In accordance with provisions of the National Environmental Policy Act of 1969, we enclose for your review the Draft Programmatic Environmental Impact Statement and Draft Management Plan (DPEIS/DMP) for the proposed Federal designation of the Mission-Aransas National Estuarine Research Reserve.

## **Correction to DPEIS for the Texas National Estuarine Research Reserve and Management Plan: The Mission-Aransas Estuary**

**FEDERAL APPROVAL OF THE  
TEXAS NATIONAL ESTUARINE RESEARCH RESERVE AND  
MANAGEMENT PLAN:  
THE MISSION-ARANSAS ESTUARY**

Figure 36. Locations of historic structures and sites listed on the National Register and General Land Office state tracts with the archeological resource management code.

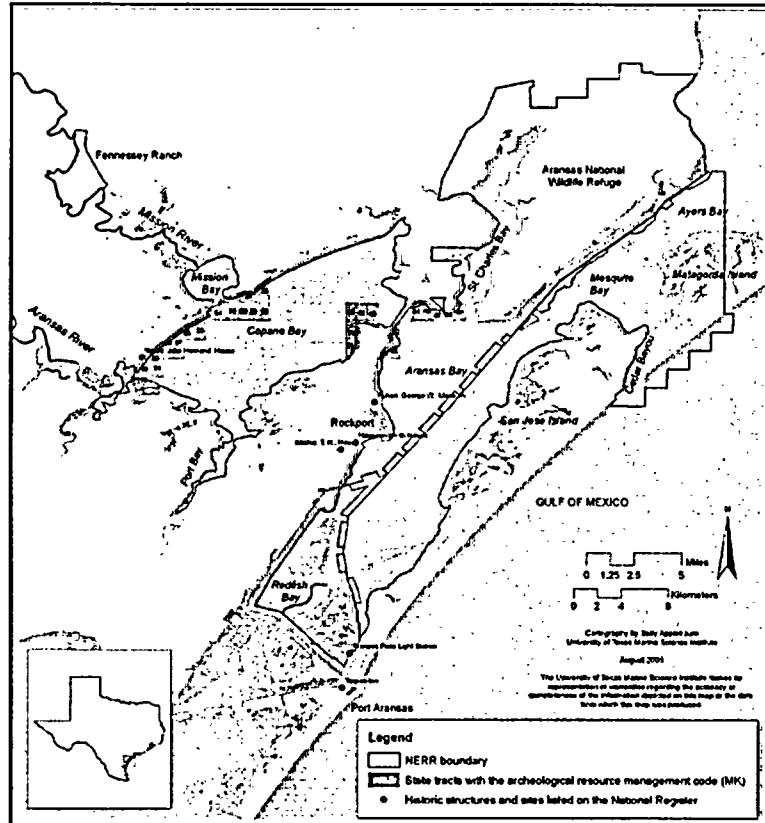
Replacement text for Section 5.7.6 National Historic Preservation Act (NHPA), Page 47:

"Under the National Historic Preservation Act of 1966, the Secretary of Interior has compiled a national register of sites of significant importance (Figure 36). NOAA believes that the Reserve and associated activities will not negatively impact registered sites or eligible sites. The draft Coastal Lease (Attachment A, Appendix 5) has a specific provision requiring the UTMSI to cease any operation if a site, object, location, or artifact of archaeological, scientific, education, cultural, or historical interest is encountered during their activities and to notify the proper authorities so that appropriate action can be taken to protect or recover the findings. NOAA has contacted the TX SHPO with its opinion that Reserve designation will not adversely impact registered or eligible sites, and is awaiting a response from the SHPO."
